# 802.3cd: proposed change in TDECQ method and reference receiver equalizer.

## Authors:

Figure 121-5—Illustration of the TDECQ measurement

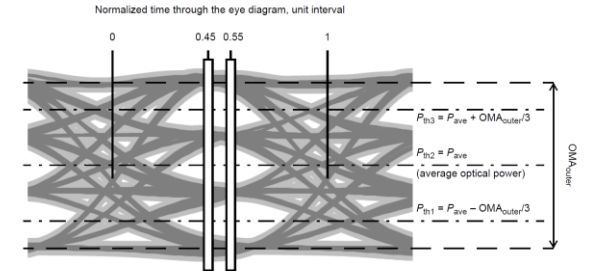
Into TDECQ method (802.3bs, 121.8.5.3), sub-eye threshold levels P<sub>th1</sub>, P<sub>th2</sub>, and P<sub>th3</sub>, are determined from the OMA<sub>outer</sub> and so are average thresholds for each of the three PAM4 eyes diagram (P<sub>ave</sub>) as defined in Equation (121-1), Equation (121-2), and Equation (121-3).

But in real implementations the optimum thresholds at lower BER are different from the average ones.

This is true even for a very clean eye, with lot of available bandwidth.

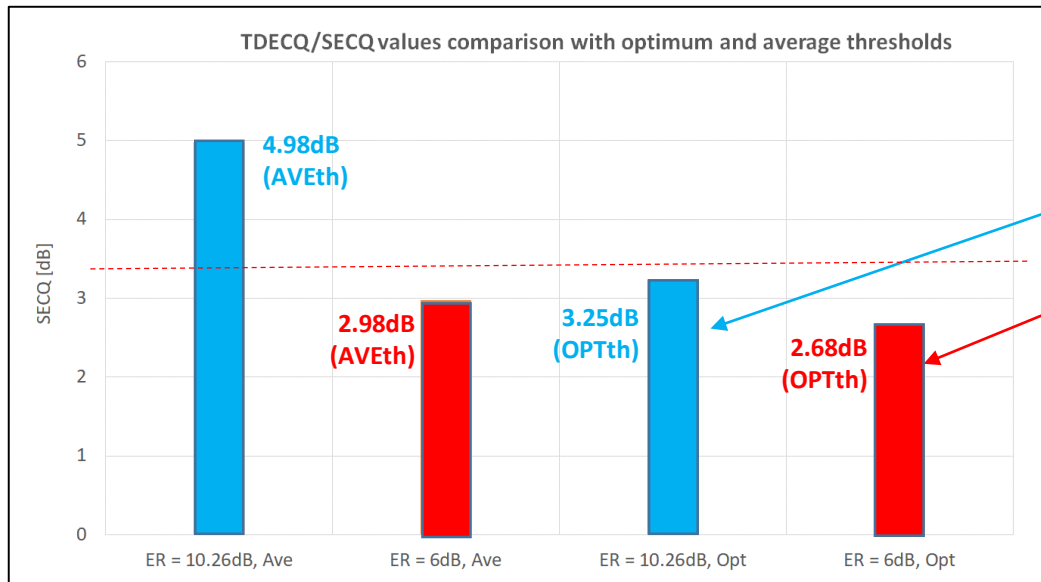
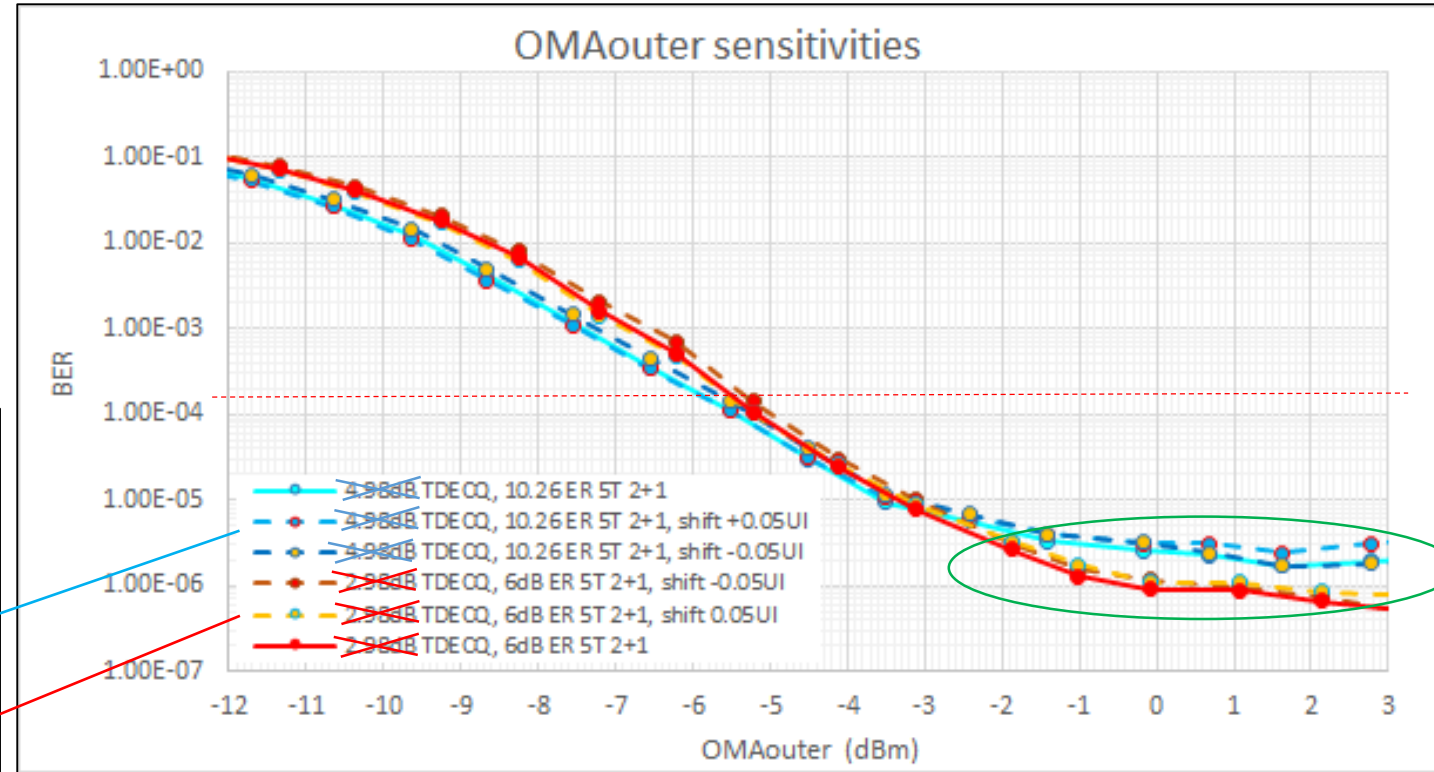
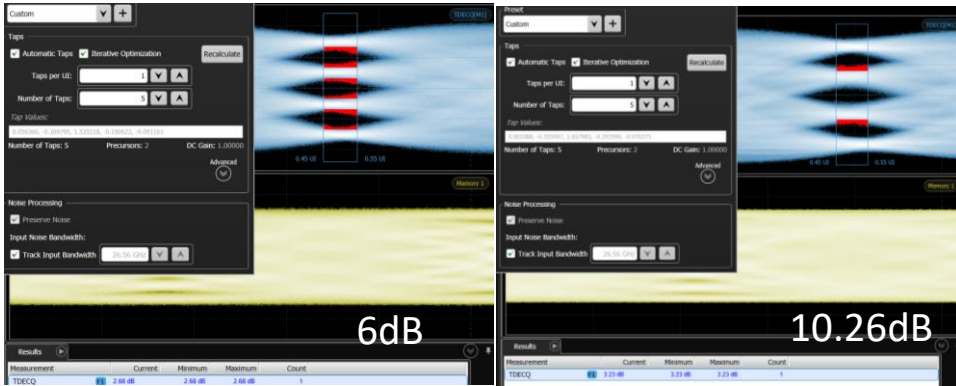
- Threshold optimization into TDECQ algorithm.
- Equalization is done at 0.5UI sample location, with 0.1UI window applied.

Both TX conditions now pass the 53GBaud SECQ limit of 3.4dB. This is more in line with the sensitivity results presented into [mazzini 3bs 01 0917](#), 1dB to 1dB match seems to be at BER floor.

- Into 802.3cd, paragraph 138.8.5 and 140.7.5, add sentence
  - **The precise threshold amplitude position is optimized to further minimize TDECQ.**
- Into paragraph 139.7.5.3, change sentence 'TDECQ for 50GBASE-FR and 50GBASE-LR is measured as described in 121.8.5.3 with the exception that the reference equalizer is as specified in 139.7.5.4 and **the precise threshold amplitude position is optimized to further minimize TDECQ**'.
